Campaign Code:
L73X-A.01.19

Campaign Name:
Rerooting of ION ECU harness

Model:
Aventador S and SV J

To: Official After-Sales Network
Subject: Rerooting of ION ECU harness
Date: Friday, January 25, 2019.
Pages: 4

A. Bracket replacement and wiring repositioning

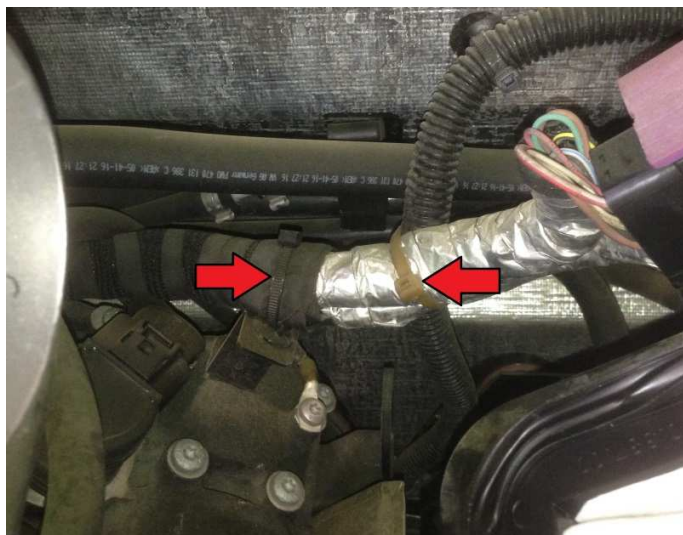
As a result of continuous product monitoring, Automobili Lamborghini Spa requests that the ION ECU wiring retainer bracket be replaced along with its partial repositioning in order to avoid interference and damage the harness.

2. If present, eliminate the twist of the wiring by disconnecting the black connector.
3. Identify retainer bracket 470854121 of the ECU ION wiring.

Open the 2 clamps and free the ION ECU wiring.

4. Remove the screw. Free and remove retainer bracket 470854121 of the ECU ION wiring.

5. Position the new steel-rubber retaining clamp N10608801 near the mark on the ION ECU wiring of the previously removed clamp.

Install the screw (N10451408) using the one supplied in the kit.

Tightening torque: **9 Nm (6,64 lbf ft)**

6. Join the ION ECU wiring branch corresponding to the black connector to the positive wire using high temperature retaining clamp N10562301.
